ENGINE - HP COMPRESSOR - INTRODUCE A NEW STAGE 3 HPC ROTOR BLADE WITH A CUT BACK CLAPPER - CATEGORY CODE 6 - MOD.ENG-72-0201

V2500-ENG-72-0201

SERVICE BULLETIN

Part section thru HP compressor - Before and after alteration
Fig.2

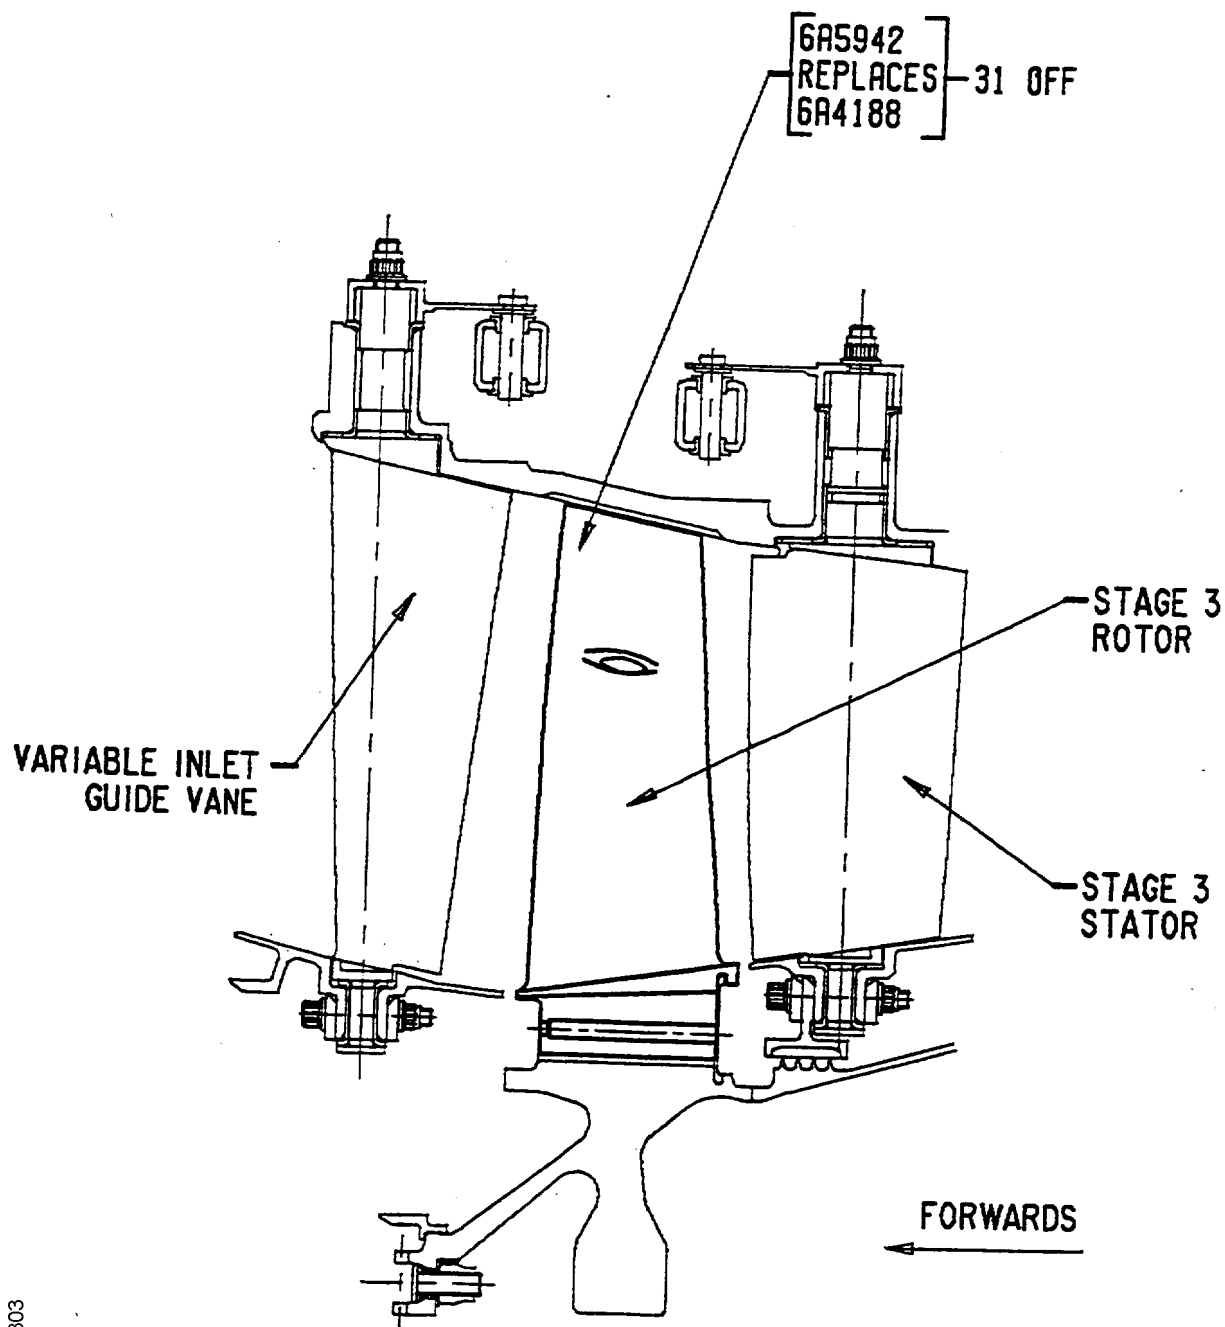
This bulletin introduces a stage 3 HP compressor rotor blade with an increased radius on the leading edge acute corner of the clapper on the convex side of the blade aerofoil.

View on stage 3 rotor blade - Reworking of stage 3 rotor blade
Fig.3

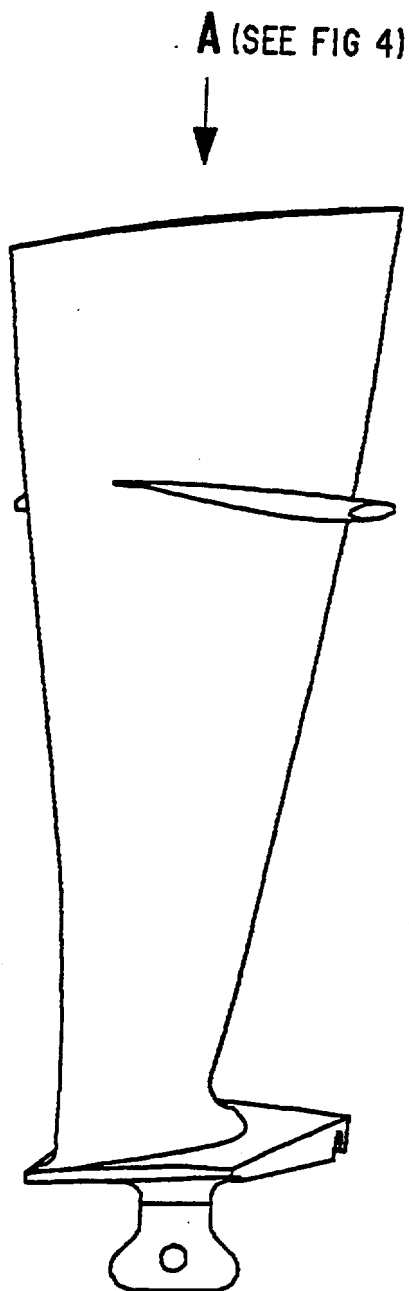
- (a) Chemically clean the HP Compressor Stage 3 Rotor Blade(s)
- (b) Cut back the corner of the clapper on the convex side of the blade airfoil

Repeat part view on A (See Figure 3) – Reworking of stage 3 rotor blades
Fig.5

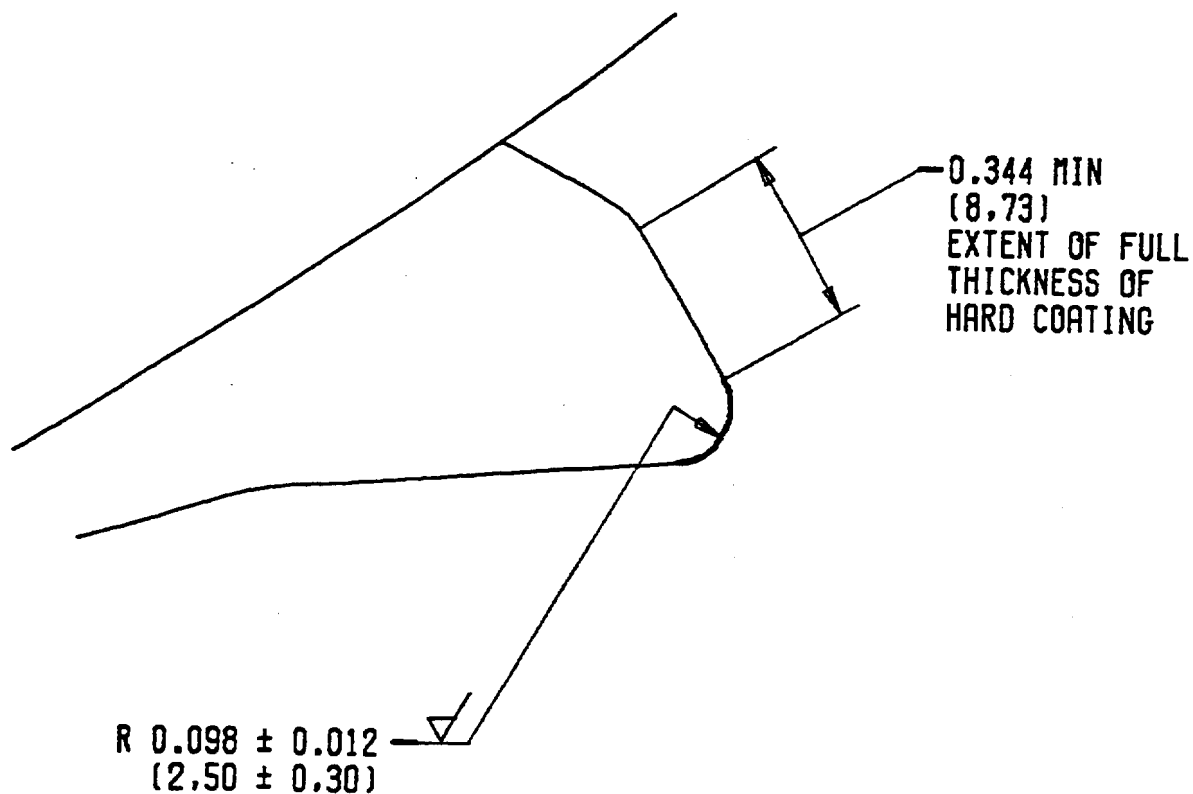
Refer to Figure 5. Use a hand file or a portable grinding machine with a locally made inspection template

| (f) Visually examine and measure the dimensions of the new radius | Refer to Figure 5. Use a locally made inspection template |
| (g) Visually examine the clapper coating | Refer to Figure 5. |

SHARP EDGE CREATED BY MACHINING RADIUS TO BE REMOVED BY BLENDING UNIFORMLY BETWEEN EXISTING LEADING AND TRAILING EDGE CORNER RADII.
